# **Rochester Hills Engineering Design Standards**

## **Proposed Revision to Chapter 4 – Stormwater Management**

**DECEMBER 5, 2022**

## **The text of Item D.3.c.i on page 4-7 shall be revised as:**

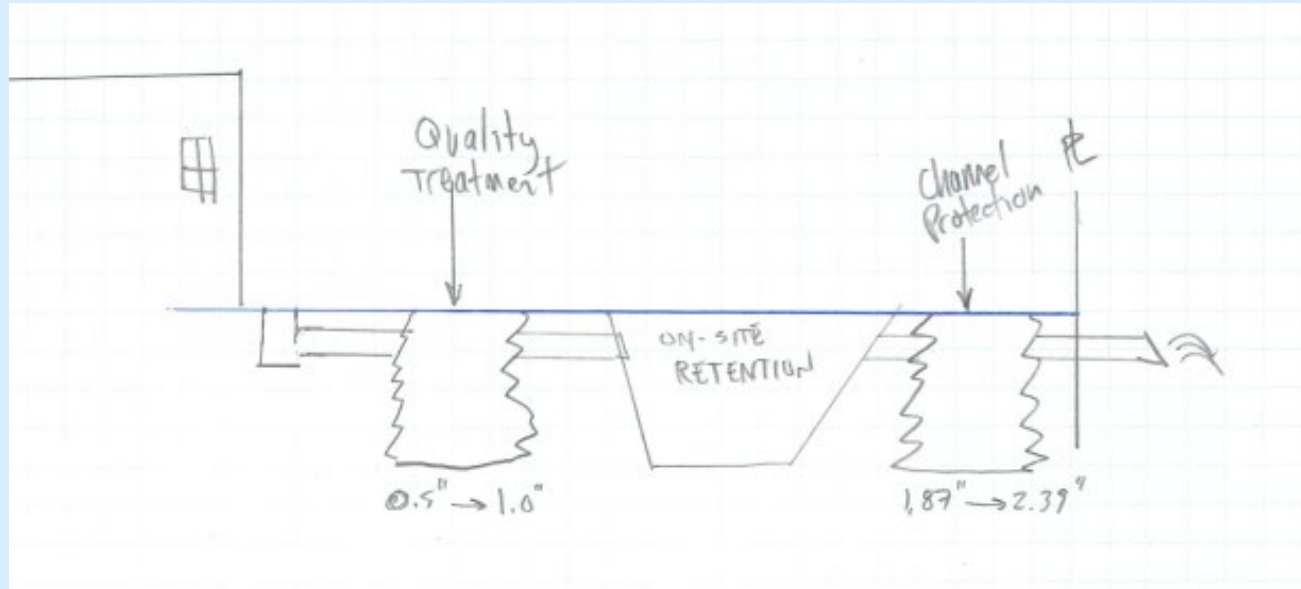
The volume of storage provided for controlling the bank full flood will be equal to or in excess of the runoff from a ~~1-year~~ **2-year** 24-hour storm, which can be determined by:
